# SERVICE BULLETIN

## Replacement of the overload clutch of ROTAX® Engine Type 914 (Series)

ATA System: 72-00-00 Engine

Fig. 1  
overload clutch

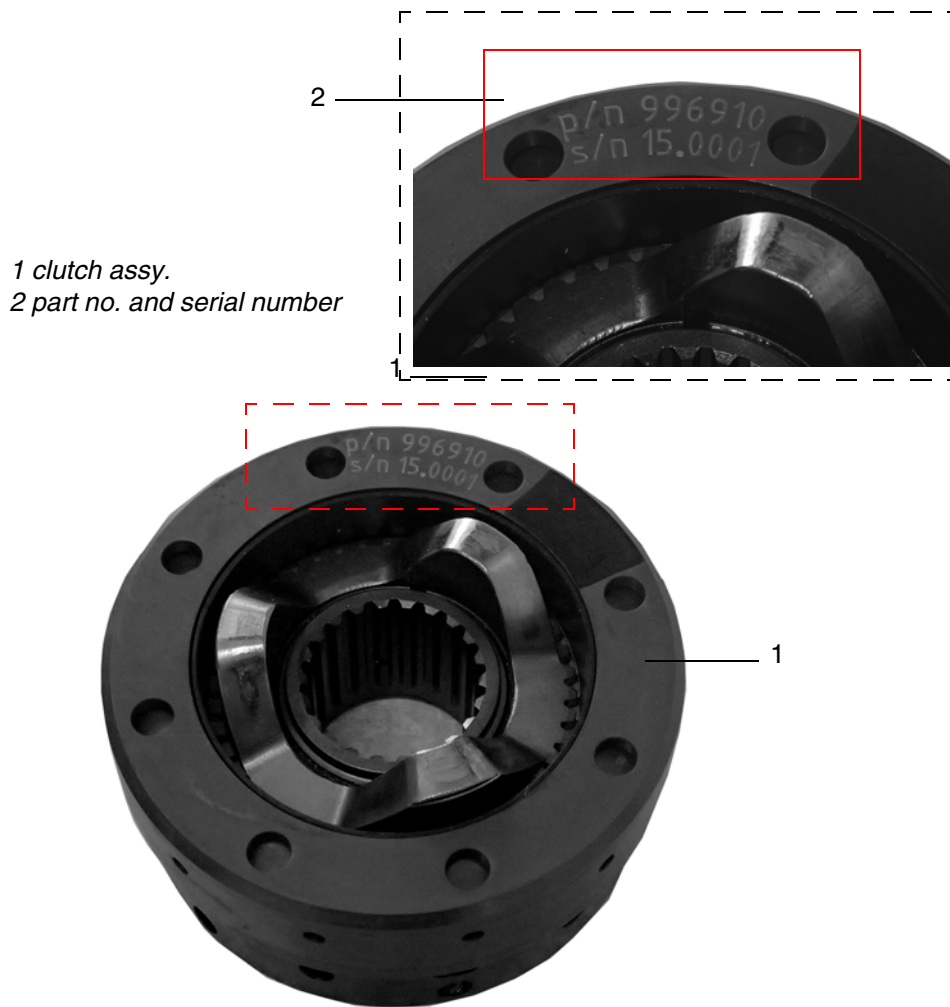
For all engines of the engine type 914 (Series), which are not affected by criterion A and/or B, overload clutches with labeled part no. and S/N on the housing must be used at an future replacement of the clutch assy.

NOTE: Spare parts labeled with part no. and S/N will be available from the date of this Service Bulletin. See Fig.1
